National Committee on Uniform Traffic Control Devices

11
12 **TOPIC:** Turning Vehicles Yield to Bicycles Sign

21
22 **AFFECTED SECTIONS OF MUTCD:** Sections 2B.53, 9B.14

RECOMMENDED MUTCD PROVISIONS/ REVISIONS:

The following two new signs are added to Figures 2B-27 and 9B-2:

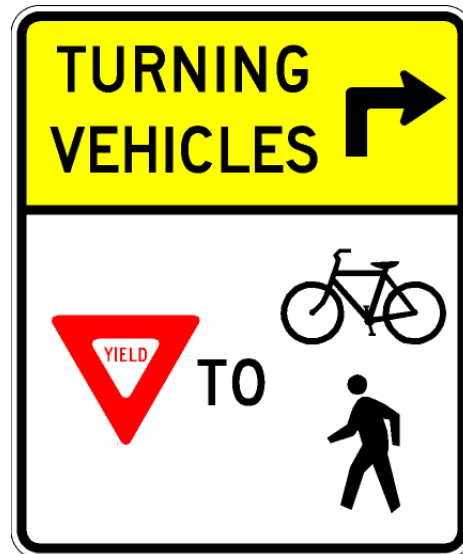
R10-15a
30" x 30"

R10-15b
30" x 36"

09 In order to remind drivers who are making turns to yield to pedestrians, bicyclists, or both, a Turning Vehicles Yield to Pedestrians (R10-15), Bicycles (R10-15a) or Pedestrians and Bicycles (R10-15b) sign (see Figure 2B-27) may be used.

06 In order to remind drivers who are making turns to yield to pedestrians, bicyclists, or both, a Turning Vehicles Yield to Pedestrians (R10-15), Bicycles (R10-15a) or Pedestrians and Bicycles (R10-15b) sign (see Figure 2B-27) may be used.
